Final Environmental Impact Report

Dignity Health North State Pavilion Project

Volume 2
FINAL
ENVIRONMENTAL IMPACT REPORT

**DIGNITY HEALTH REDDING
NORTH STATE PAVILION PROJECT**

CVFPB JURISDICTION EXHIBIT

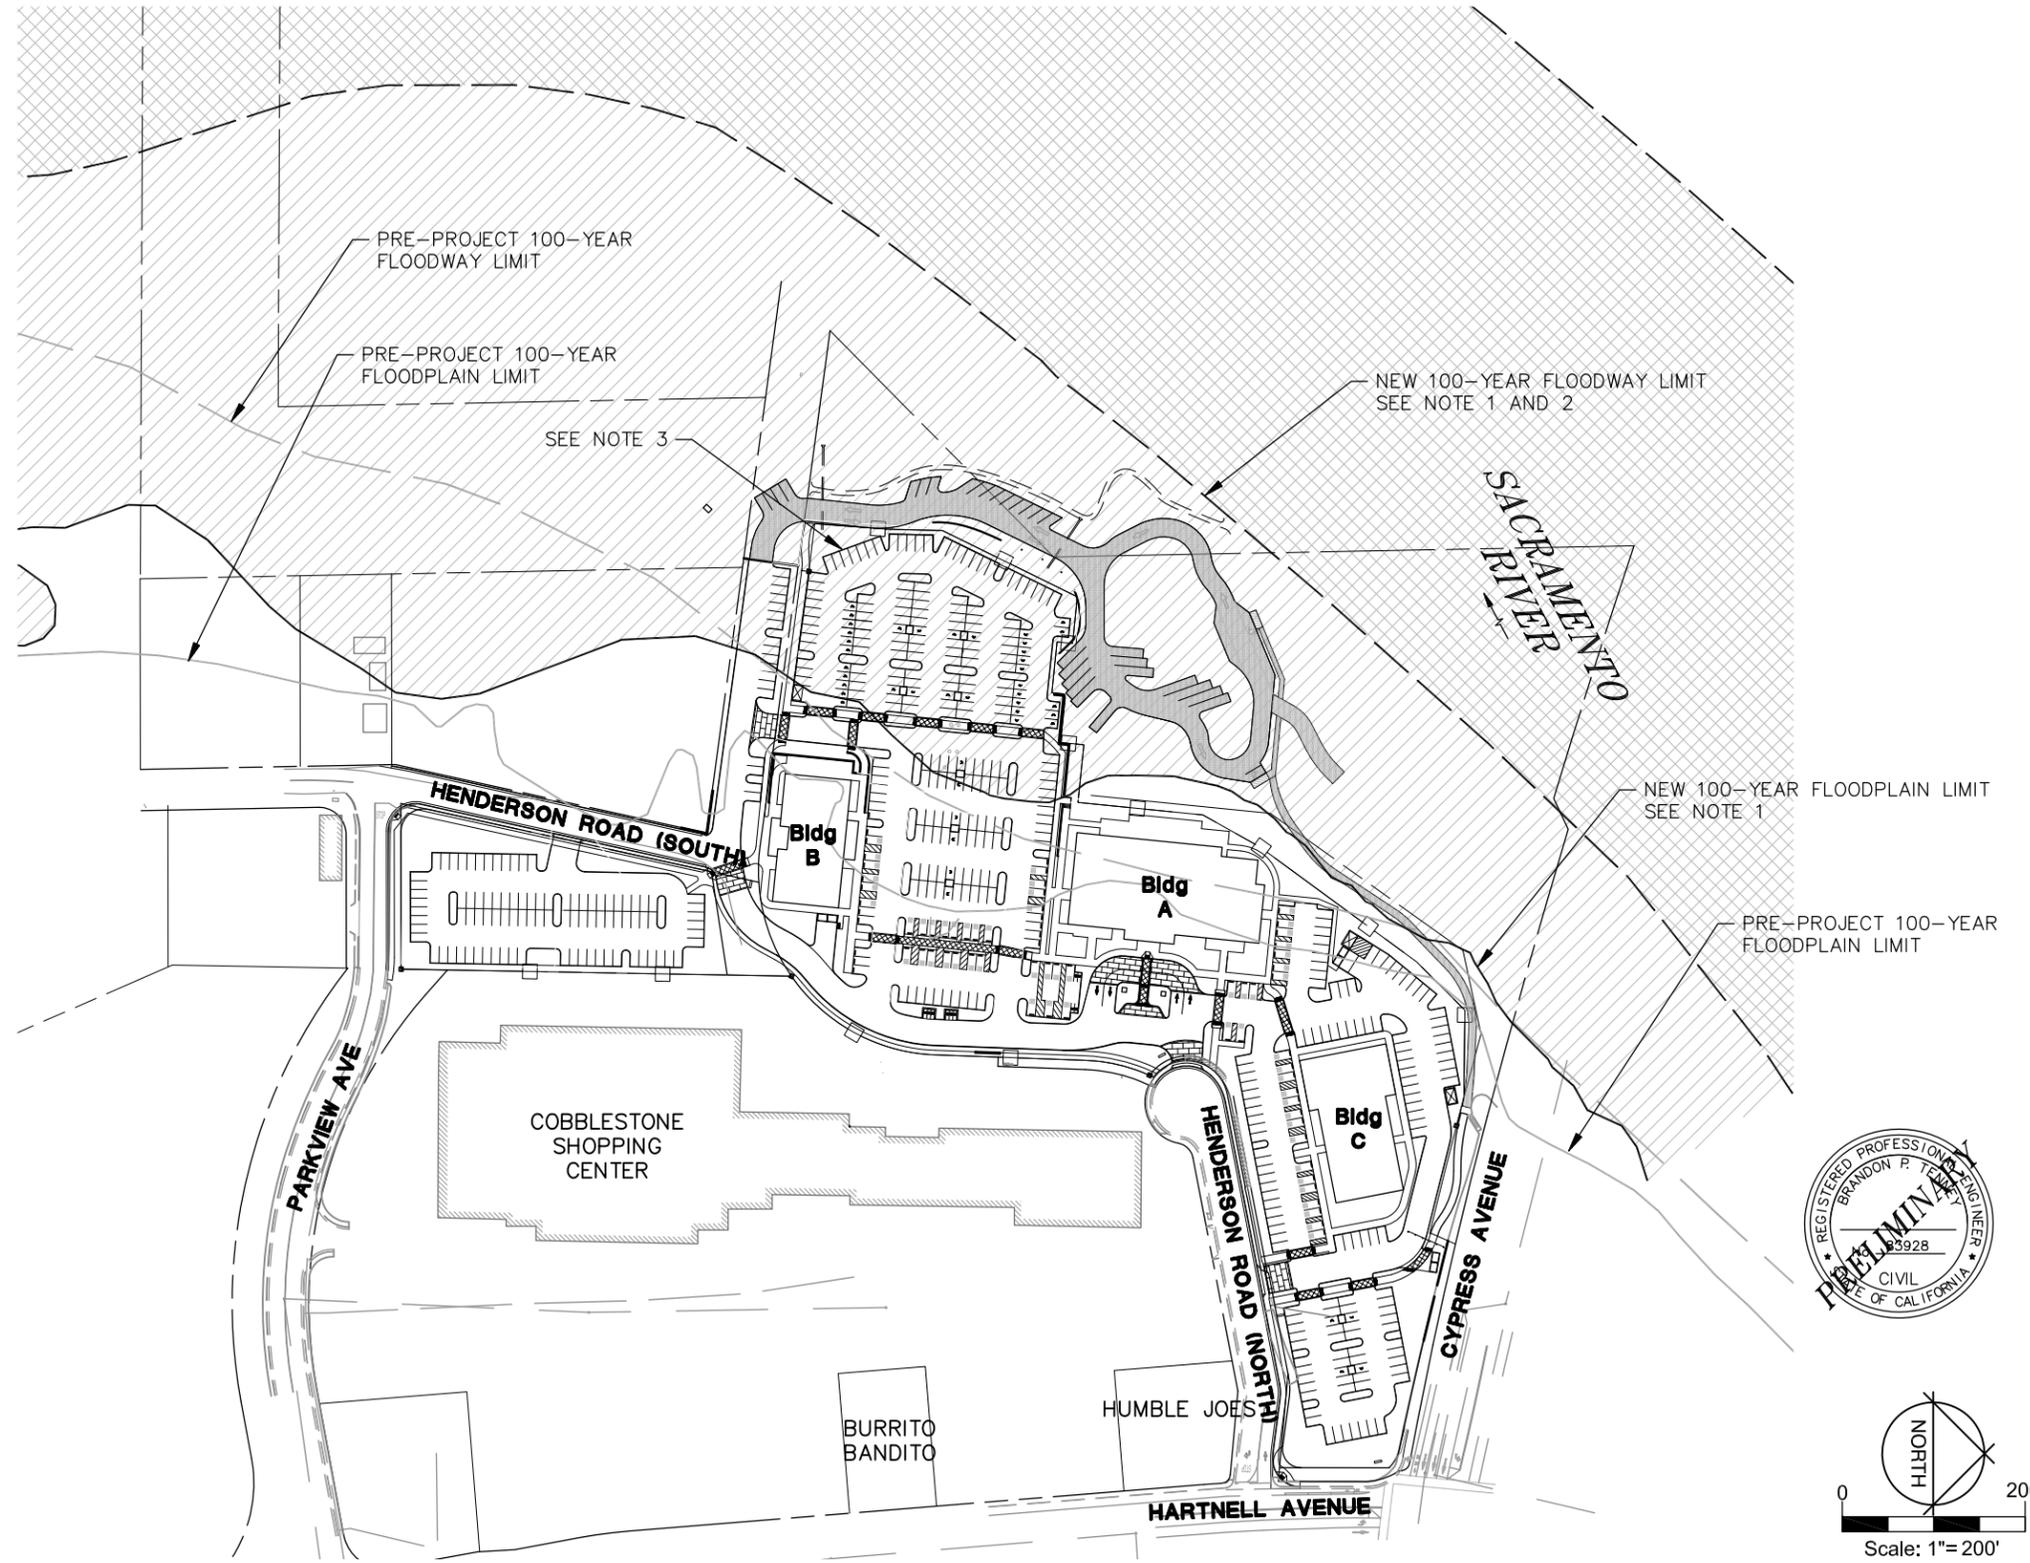
Response 3: The participation of the Central Valley Flood Protection Board (CVFPB) in the public review of this document is appreciated. The CVFPB identifies the project site as being under its jurisdiction which includes all tributaries and distributaries of the Sacramento and San Joaquin Rivers, and the Tulare and Buena Vista basins south of the San Joaquin River. As a result, the CVFPB suggests that a permit may be required prior to commencing activities within CVFPB's jurisdiction. Such activities include the placement, construction, reconstruction, removal, or abandonment of any landscaping, culvert, bridge, conduit, fence, projection, fill, embankment, building, structure, obstruction, encroachment, excavation, the planting, or removal of vegetation, and any repair or maintenance that involves cutting into a levee.

It is important to note that the final LOMR was approved by FEMA on November 27, 2019. Generally, the LOMR shifted the floodplain limit by variable amounts adjacent to the site, from about approximately 40 feet to approximately 150 feet to the west. The floodway was also shifted by varying amounts, from approximately 200 feet west at the north end to over 500 feet west on the south end. For reference, an illustration depicting both limits is attached to this response.

As noted on the illustration, the CVFPB's jurisdiction differs from the FEMA mapped floodplain. Although a CVFPB permit does not appear to be required at this time, City staff, in coordination with the applicant, will coordinate with the CVFPB during final design to assess the actual need for a permit.

PARKING STRUCTURE ALTERNATIVES

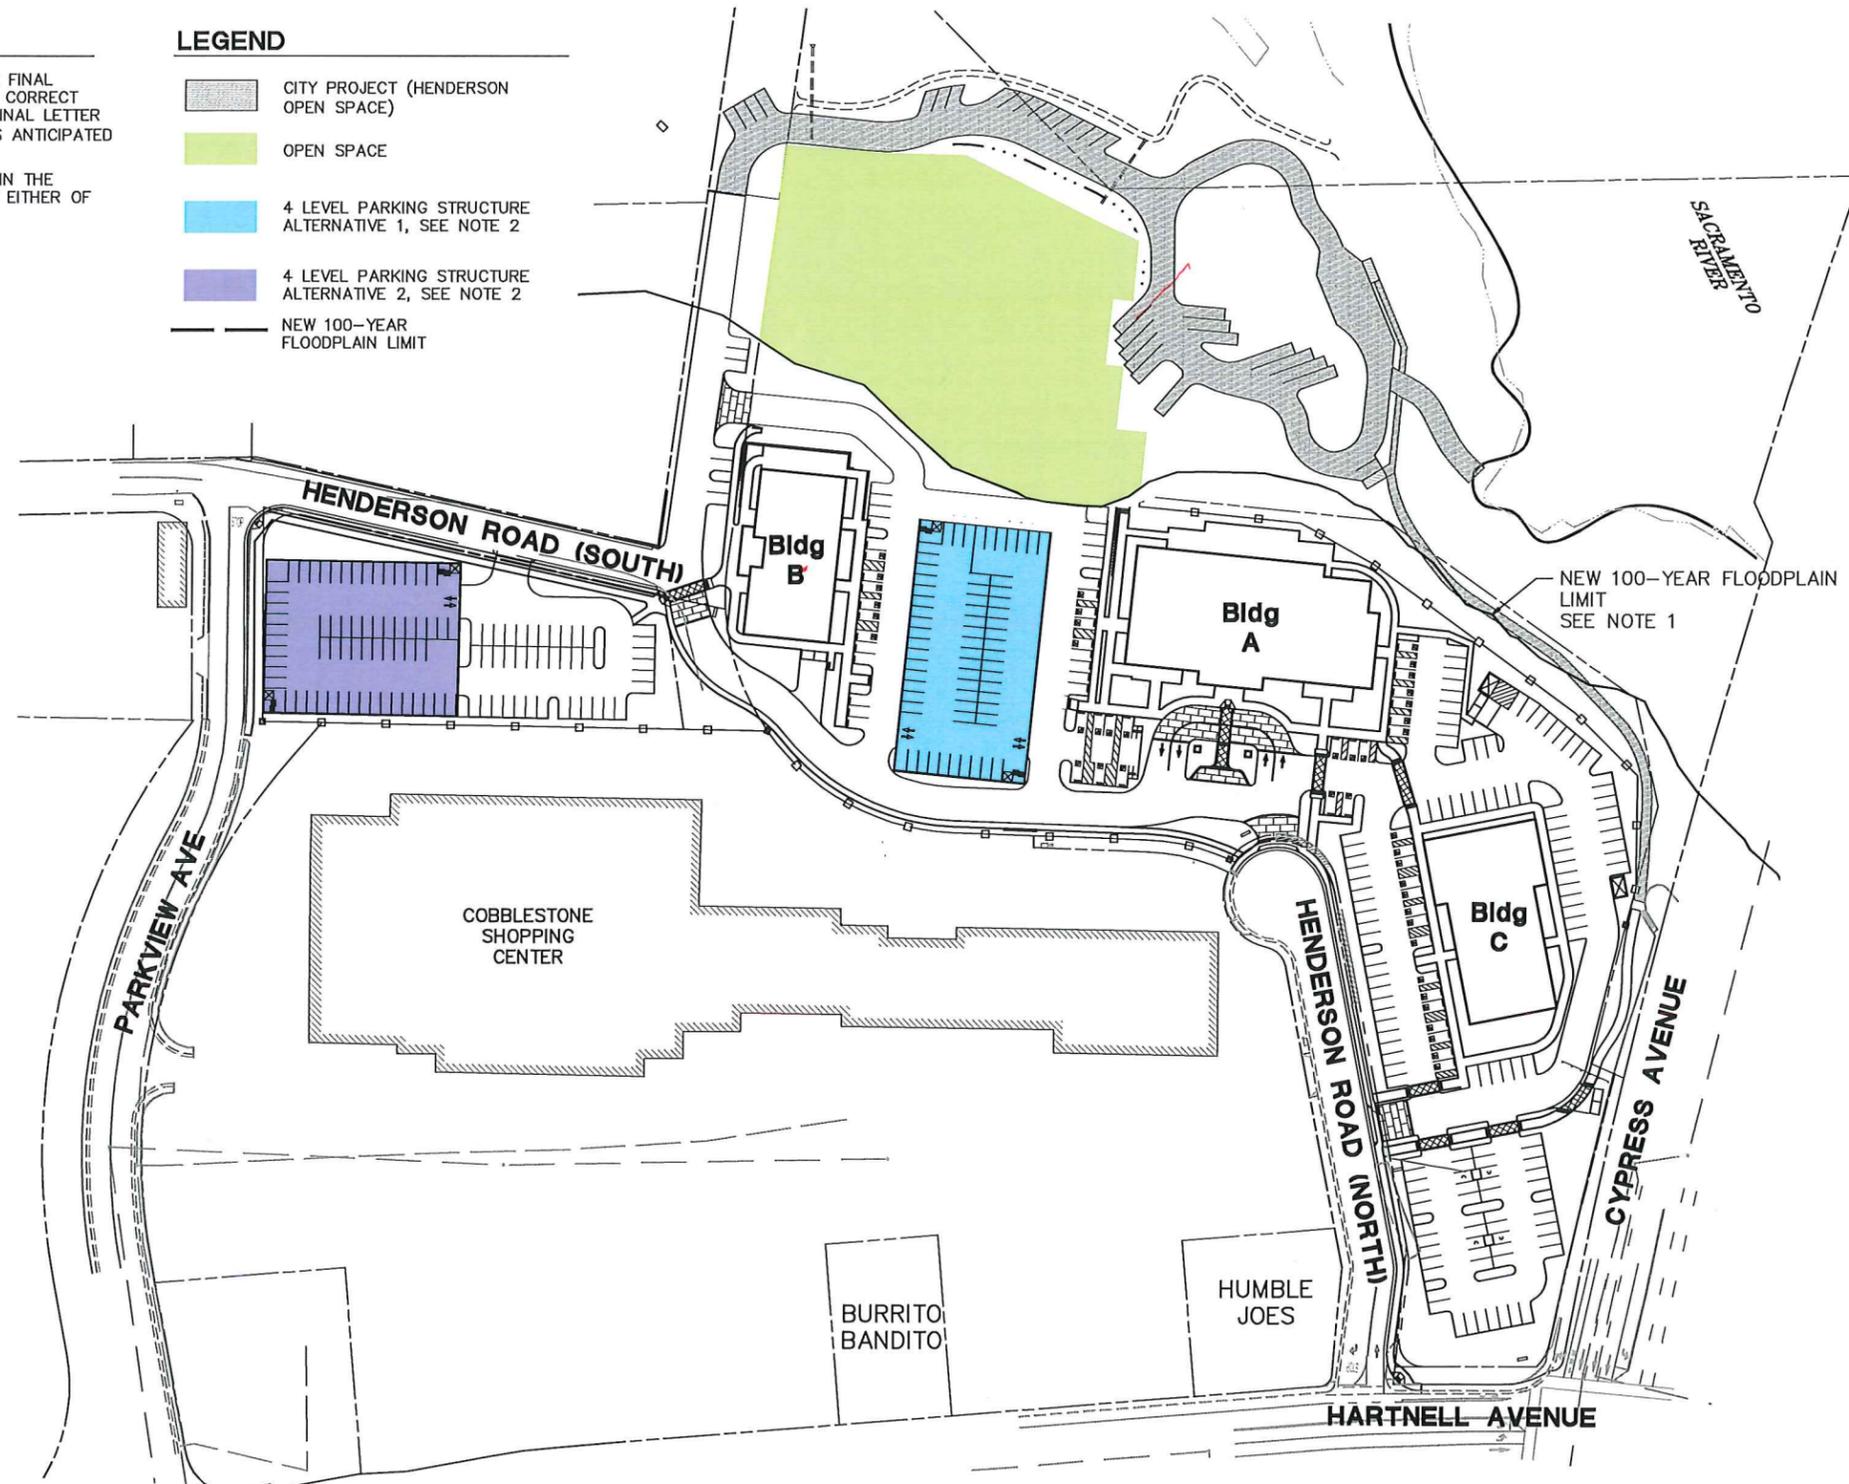
Response 4f: CDFW notes that the tree survey report identifies 15 candidate trees, 12 of which are proposed to be removed, and recommends a redesign of the project to avoid removal of these trees and development in the floodplain through the use of a multi-level parking structure.

During preliminary design efforts, the applicant considered onsite parking lot variations, including the concept of constructing a multi-level parking structure at two different locations that would eliminate development in the floodplain and allow retention of additional candidate trees (refer to the attached figure depicting the location of the two parking structure alternatives). Under both alternative parking structure designs, the following would occur:

- A four-level parking structure would be constructed to provide approximately 250 spaces. This would be sufficient to replace the 183 spaces that would be eliminated from the floodplain, as well as the 65 (Alternative 1) or 53 (Alternative 2) surface spaces that would be eliminated in the parking structure location.
- The top deck of the parking structure would be 30 to 35 feet above the surrounding parking areas and would have ±20-foot tall parking light poles on the top deck. The uppermost parking light fixtures would be 50 to 55 feet above the surrounding parking areas.

- The concentration of parking into a multi-level structure would change the site circulation, including possibly shifting a portion of the traffic load from Henderson Road (North) to Henderson Road (South) and Parkview Avenue. This effect would be more pronounced with Alternative 2.
- Approximately 1.4 acres of floodplain previously slated for surface parking spaces would instead remain undeveloped.
- Four candidate trees previously slated for removal would be retained on the project site.

The Alternative 1 parking structure concept provides for a four-level 250 space structure generally located between Building 'A' and Building 'B', adjacent to the open space and riparian area between the site and the Henderson and Parkview Open Space Restoration Trail and Kayak Access Project. As discussed in **Response 4b**, the loss of floodplain benefits as a result of the proposed project is not considered as a significant impact when compared to historical and baseline conditions. The loss of riparian habitat and candidate trees as a result of the proposed project would be offset (mitigated to less than significant levels) through implementation of the proposed landscaping plan and offsite riparian habitat planting. In contrast, construction of a multi-level parking structure under Alternative 1 would compound the *significant and unavoidable* impacts of the proposed project related to aesthetics given the structure's proximity to the Sacramento River. In addition, a parking structure at this location would also increase the potential for light spillage into the adjoining riparian areas, which would contribute to adverse biological effects. Thus, although the Alternative 1 parking structure would contribute to the worsening of the significant aesthetic impact of the proposed project, the structure is not necessary to avoid any significant biological impacts. Thus, nothing in CEQA, which is concerned primarily with reducing or avoiding significant environmental effects, favors the construction of the Alternative 1 parking structure under the circumstances in which the project is being proposed.

the parking structure with parking light fixtures between 50 and 55 feet above ground surface would increase the potential for light spillage into residents located approximately 100 feet to the southwest. In addition, the concentration of parking into a multi-level parking structure would change the site circulation, including possibly shifting a portion of the traffic load from Henderson Road (North) to Henderson Road (South) and Parkview Avenue resulting in greater traffic along Parkview Avenue and potentially resulting in an increased amount of cut-through traffic along Wilshire Drive.
